Mr. Chad Staniszewski  
Mr. Eugene Melnyk  
New York State Department of Environmental Conservation  
270 Michigan Avenue  
Buffalo, NY 14203  
**OU-2 Site Walk**  
**NYSDEC Site No. C915201C**

OU2  
COVER AREAS  
Project 3617-16-7397  
Figure 1

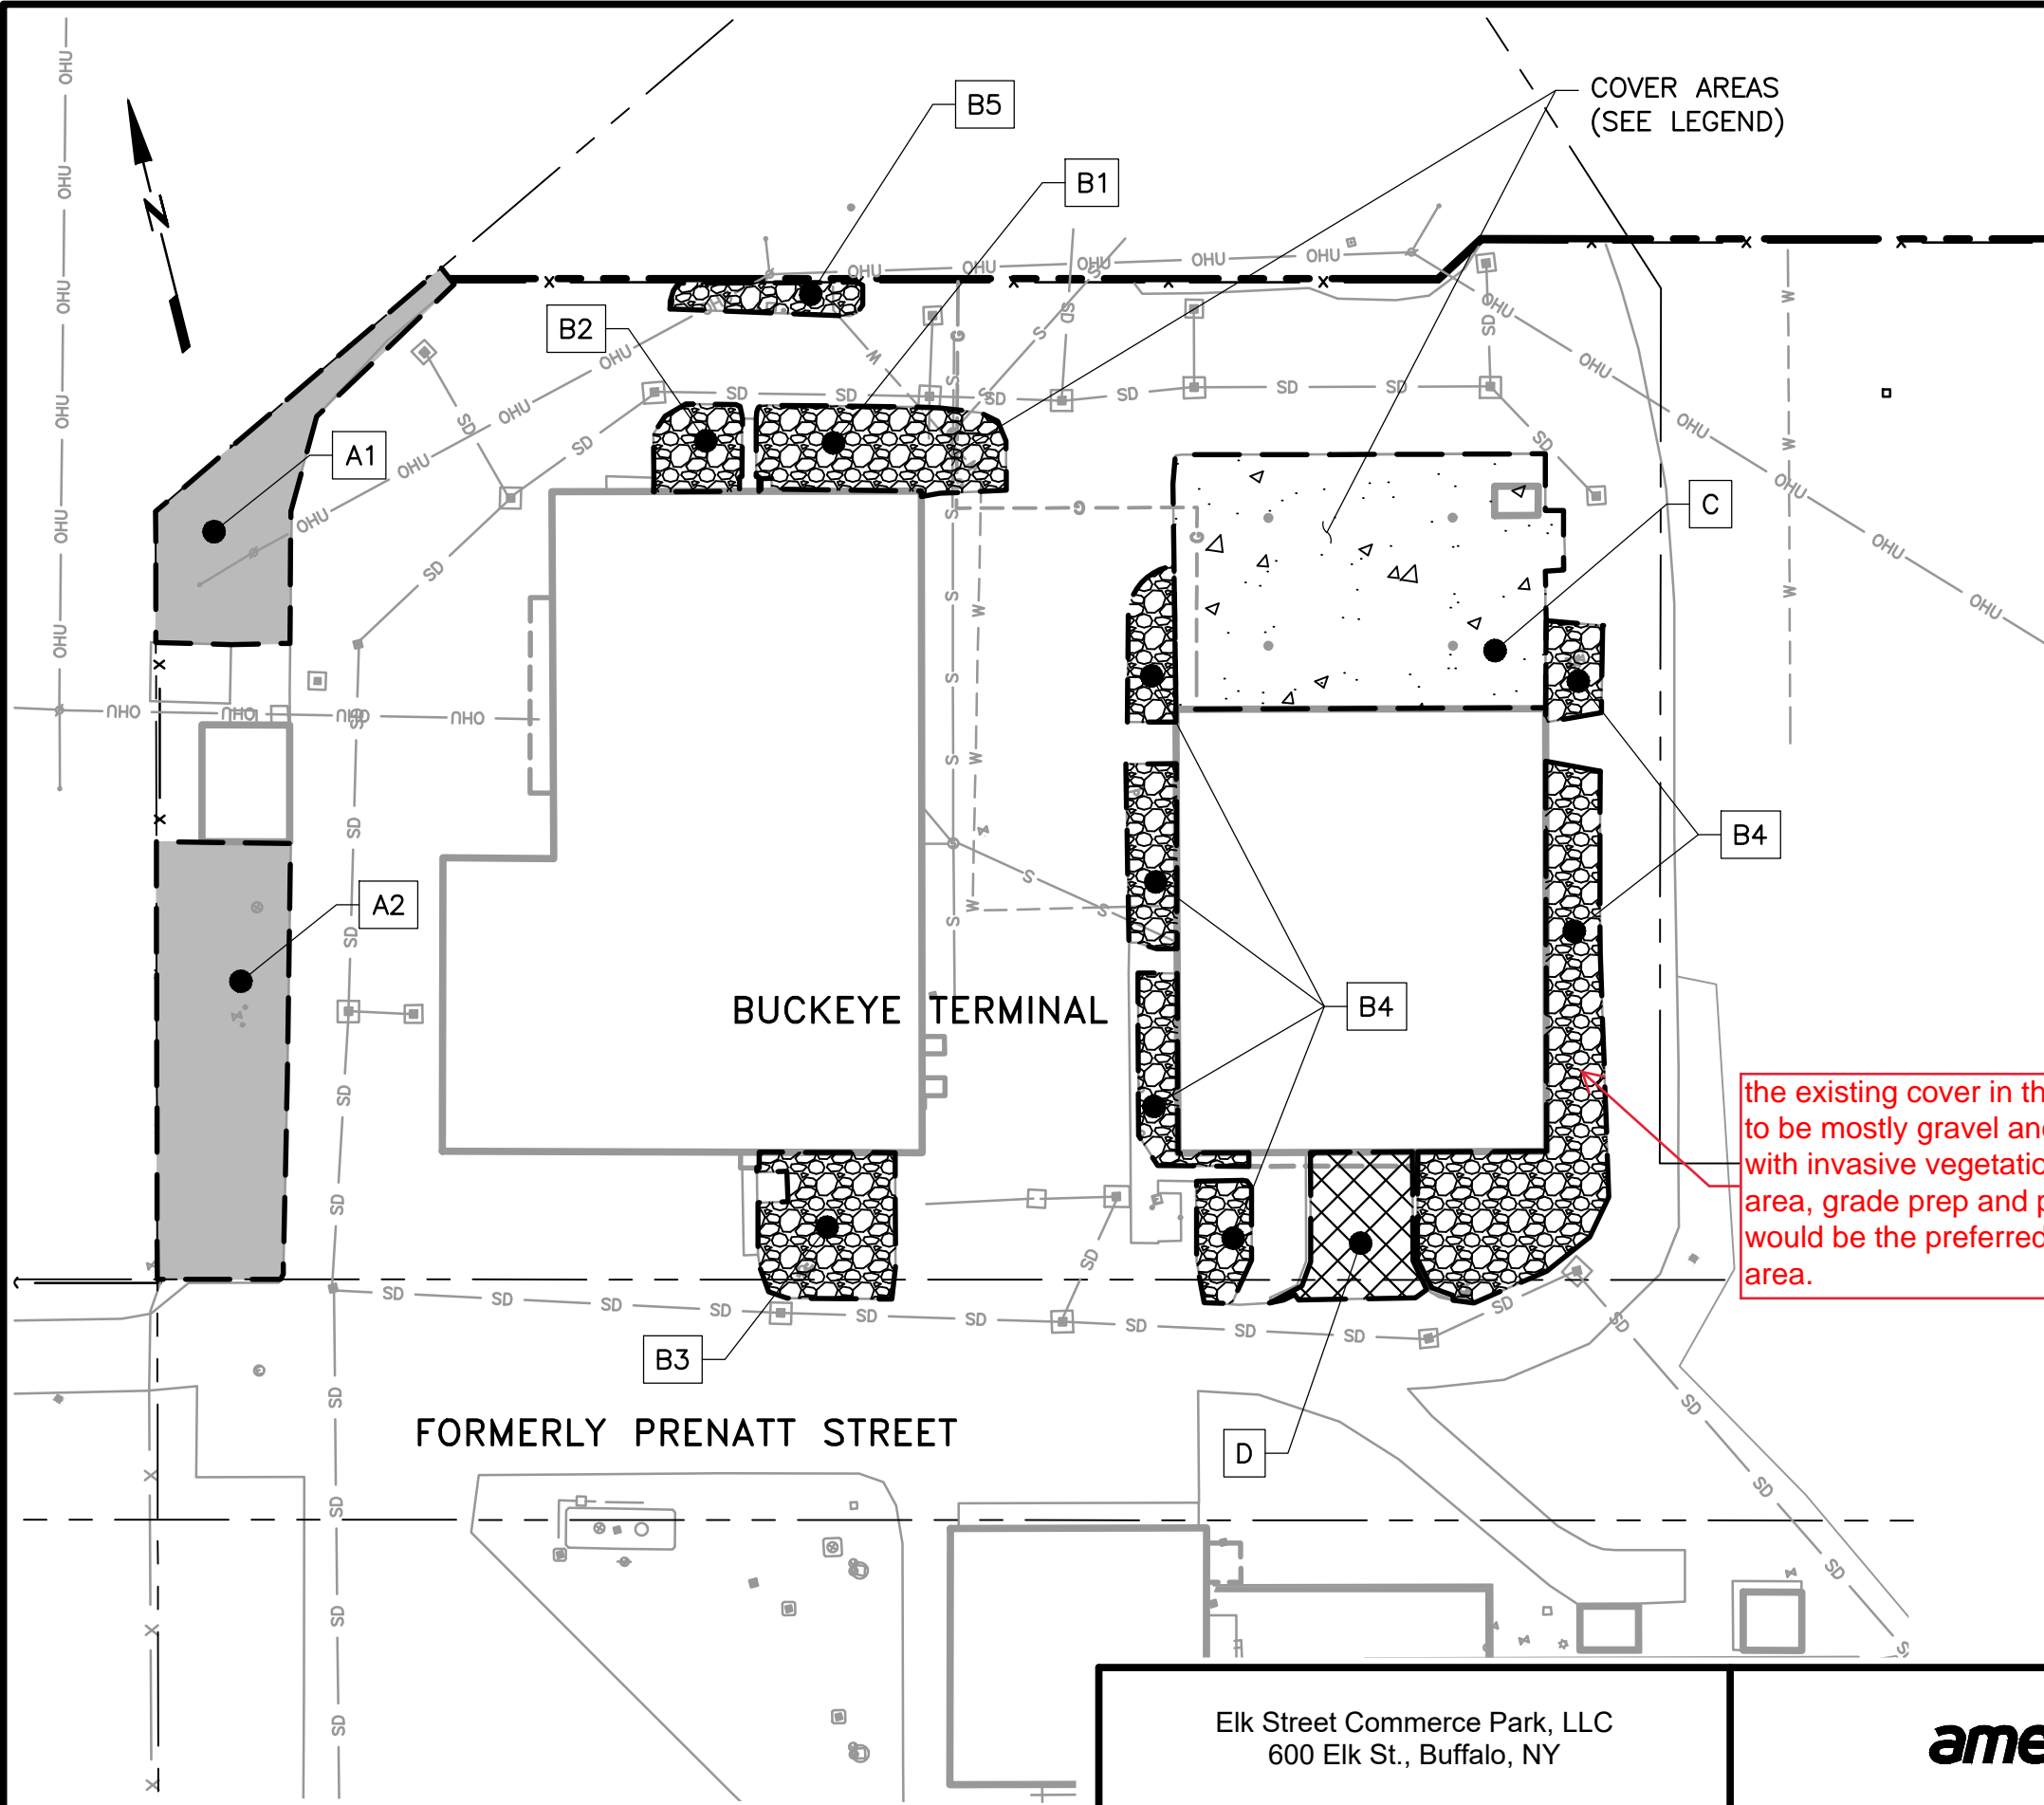
A permeable cover consisting of gravel only is not acceptable as it would promote infiltration. A permeable cover could remain in this area provided the cover consisted of 12 inches of "verified clean" soil to maintain a green area for aesthetics. Otherwise a low perm cover such as an asphalt cover is suggested to minimize infiltration.

A permeable cover consisting of gravel only is not acceptable as it would promote infiltration. A permeable cover could remain in this area provided the cover consisted of 12 inches of "verified clean" soil to maintain a green area for aesthetics. Otherwise a low perm cover such as an asphalt cover is suggested to minimize infiltration.

the existing cover in this area appears to be mostly gravel and is overgrown with invasive vegetation. Clearing the area, grade prep and placing asphalt would be the preferred cover in this area.
